EA2024-1237

**SUBJECT:** Electric Distribution Audit of PG&E's East Bay Division

**PG&E EAST BAY DIVISION  
ELECTRIC DISTRIBUTION AUDIT FINDINGS  
OCTOBER 21 – 25, 2024**

Figure 1: Guy slack limit, TD-2305M-JA02 Rev13

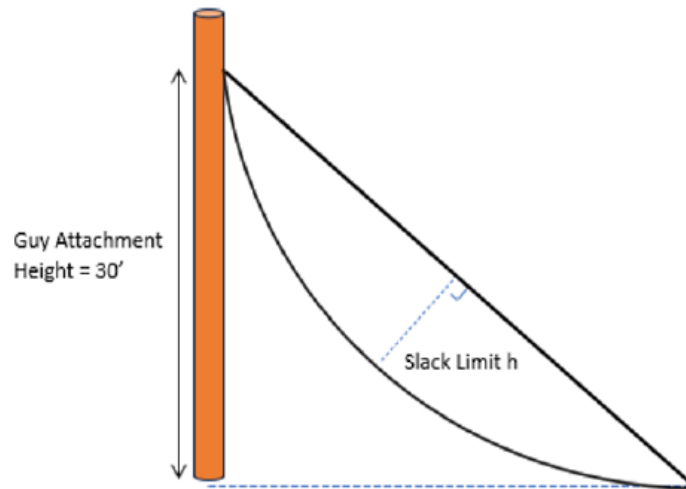
Per GO 95, Rule 56.2, guys are to be maintained taut<sup>1</sup>. PG&E's TD-2305M-JA02 allows a deviation from taut by as much as 3 feet without regard to length or angle of attachment.<sup>2</sup>

PG&E’s TD-2305M-JA02, Job Aid, Miscellaneous Other Compelling Abnormal Conditions, Guy Broken/Slack/Corroded does not comply with GO 95, Rule 56.2, which requires guys to be maintained taut in all circumstances.
